**FAY, SPOFFORD &
THORNDIKE**
778 Main Street, Suite 8
South Portland, ME 04106
Toll Free: 800.835.8666
Main: 207.775.1121
Fax: 207.879.0896
www.fstinc.com

August 9, 2013

**Subject: Proposed Truck Loading Area – 56 Milliken Street
Application ID: 2013-181
Comments from City of Portland Staff**

AT-1

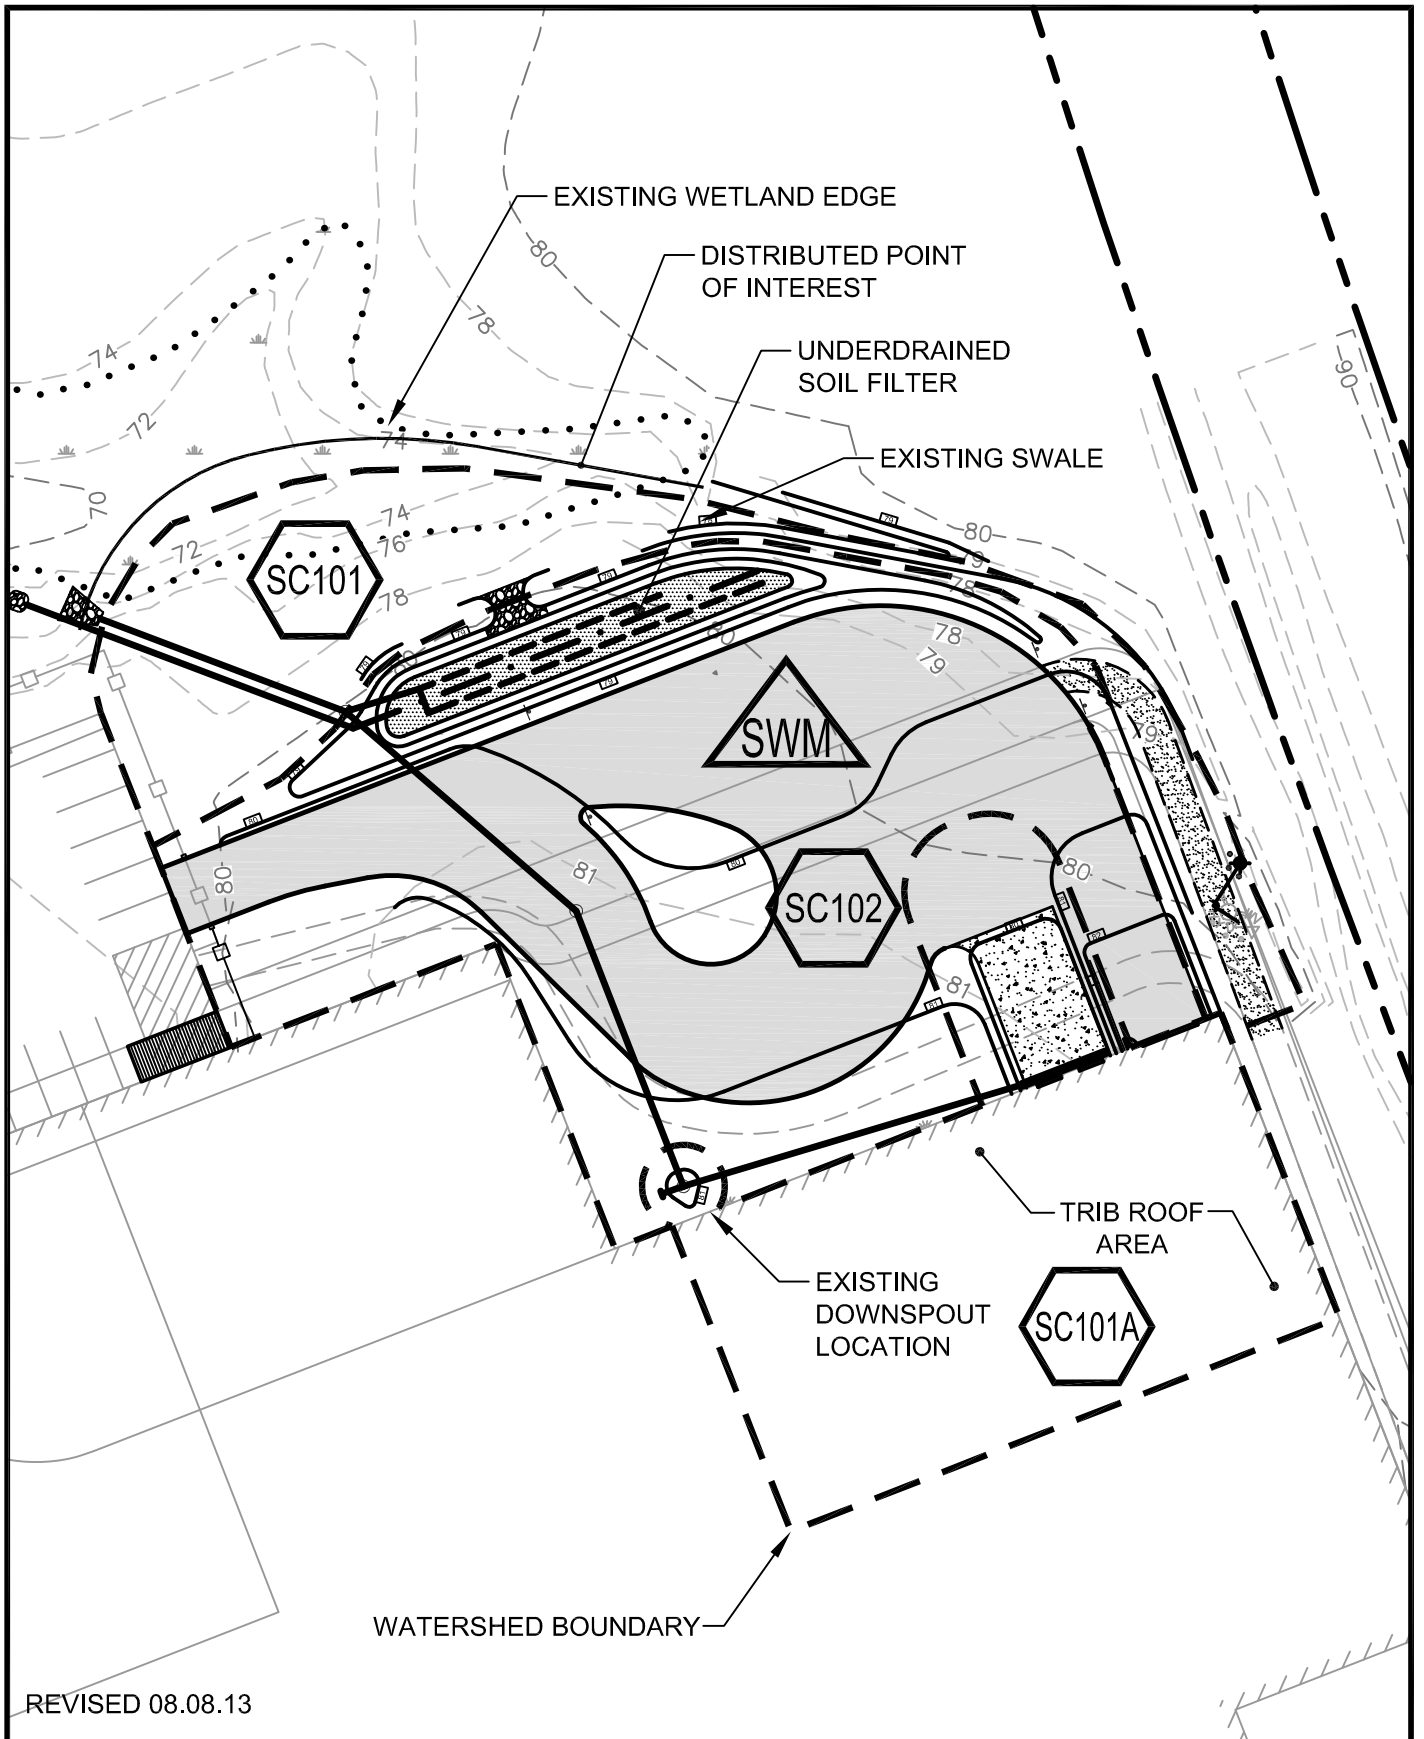
Is there any options to decrease the impervious area as related to this project?

The applicant should provide auto-turn template graphics that support the proposed pavement area. It is suggested that pavement area be reduced if it can work from a truck circulation perspective.

Figure AT-1 included with the submission materials shows the AutoTURN movement for the WB-67. The figure shows support for the extent of pavement provided. Ideally, we would have liked to actually provide a greater area for truck maneuvering given the WB-67 design vehicle. However, the applicant has chosen to go with as minimal area as we felt comfortable with particularly given the moderate level of use anticipated for the new docks.

See Figure AT-1 included with the original submission materials. This figure shows that the WB-67 design vehicle must maneuver into a 180 degree change of direction before reversing into the loading bays. This is not the most desirable but does eliminate additional pavement that would have otherwise extend out 50 feet or more in front of the loading bays.

WS-2

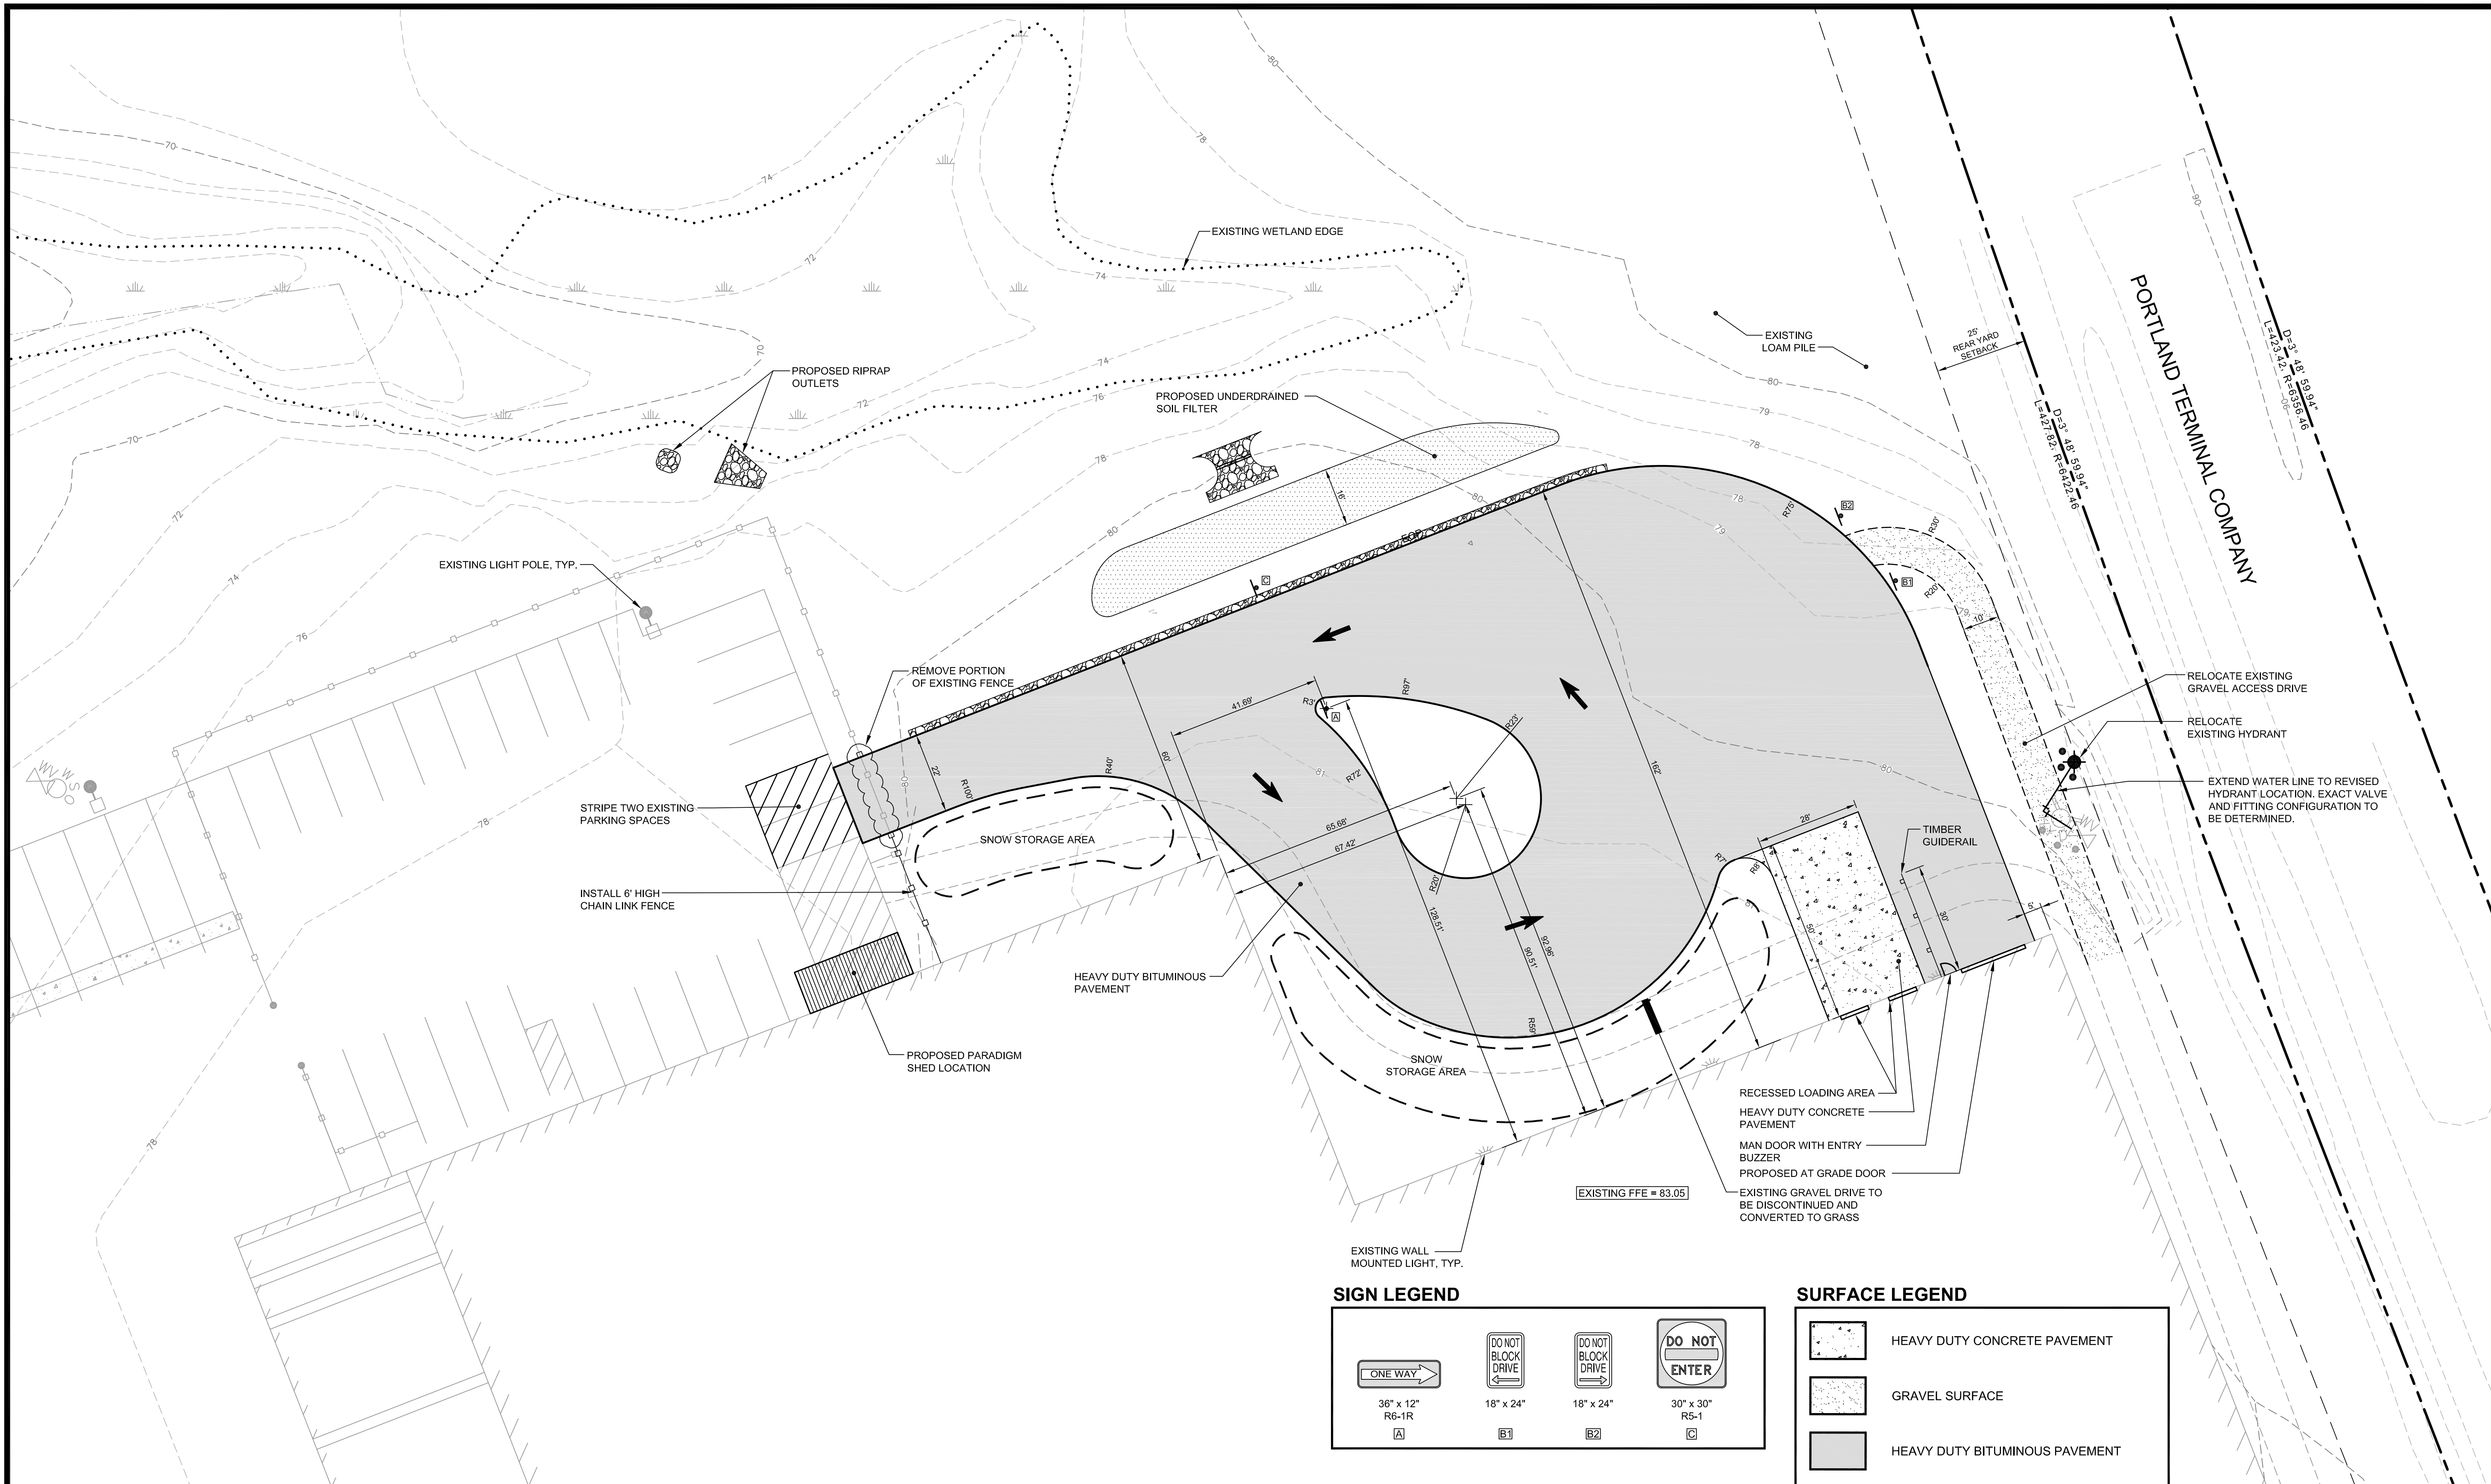
3) Figure WS2 - Post Development Watershed Map: The SC102 and SC101A boundaries do not appear to reflect the extent of the capture area associated with the proposed loading dock trench drain. If the capture area for the trench drain is greater than currently reflected on the figure, the Applicant shall recalculate the "impervious area treated" number for the project.

The WS-2 Map has been revised. No updates to computation were necessary. The revised figure represents the values in the model.

FAY, SPOFFORD & THORNDIKE, INC. ENGINEERS · PLANNERS · SCIENTISTS 778 MAIN ST, SUITE 8, SOUTH PORTLAND, ME 04106	DRAWN: CMW DESIGNED: RJW CHECKED: RJW FILE NAME: 3215-SP SHEET: C-2.0	DATE: JULY 2013 SCALE: 1" = 20' JOB NO. 3215
---	---	--

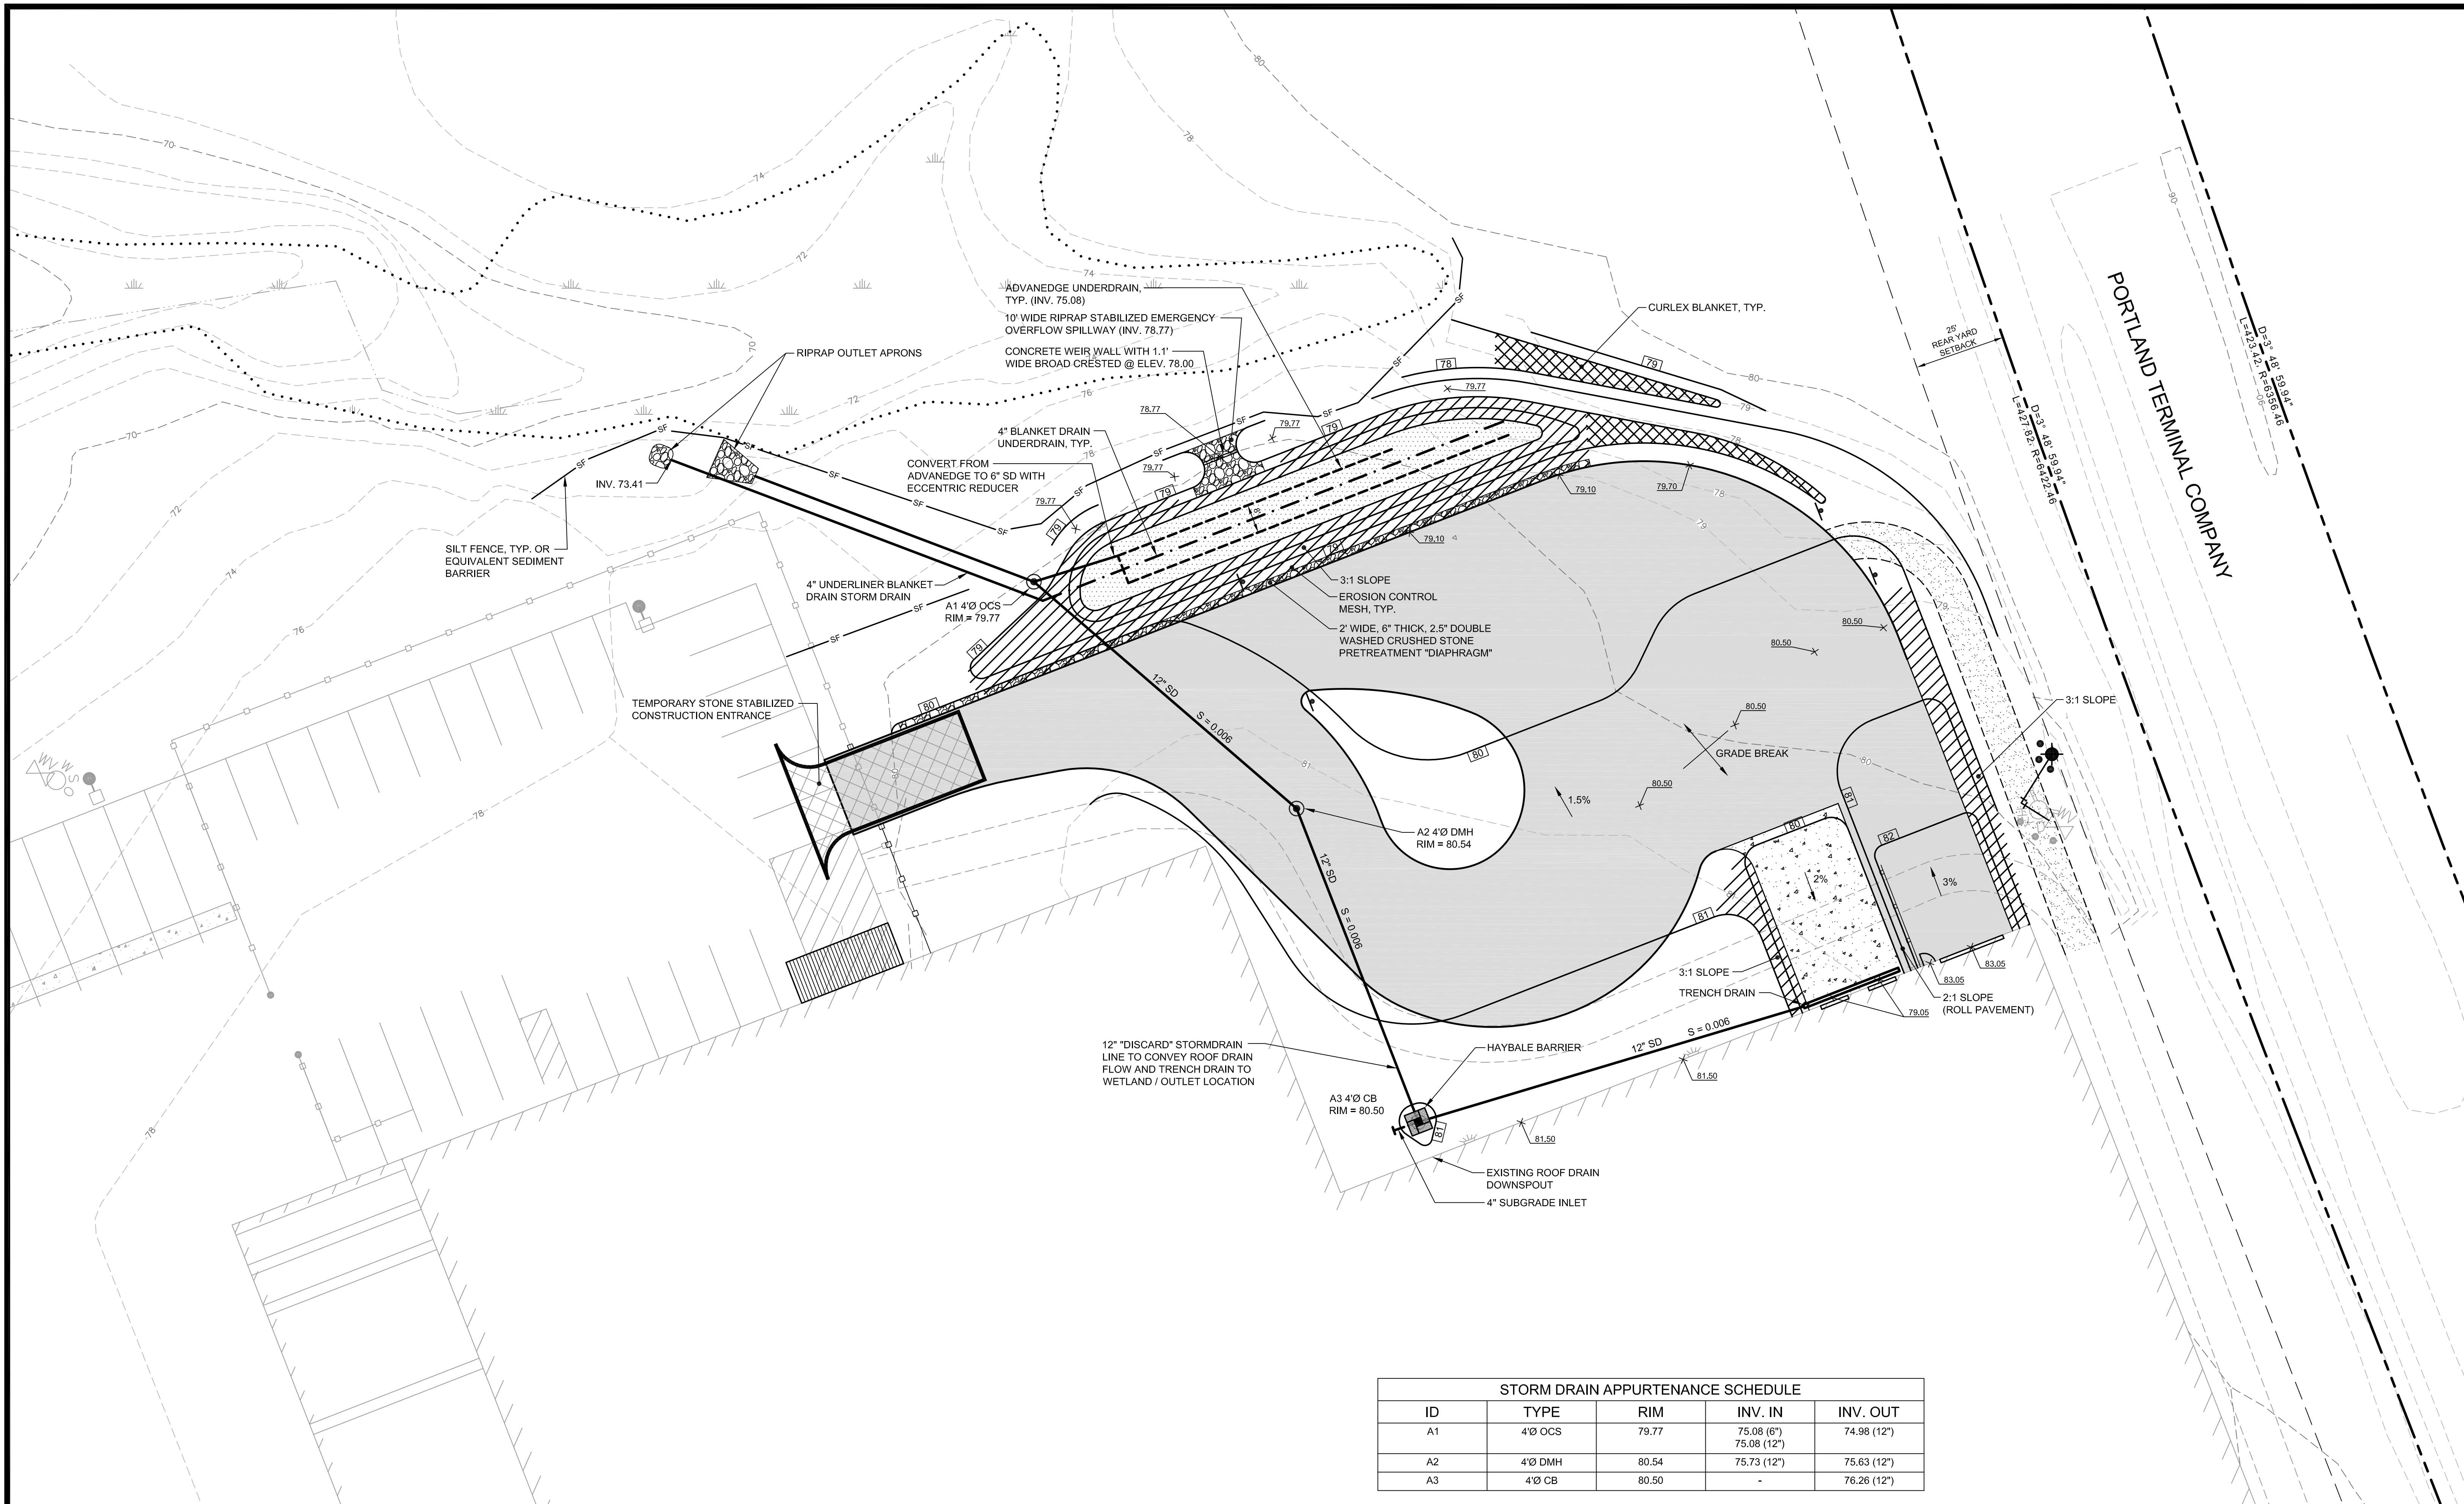
The I-M zone has a minimum 10' pavement setback requirement. I measure approximately 53' to the RR tracks in the rear.

No response necessary. The maximum impervious ratio on Sheet C-2.0 has been revised from 100 percent to 75%.
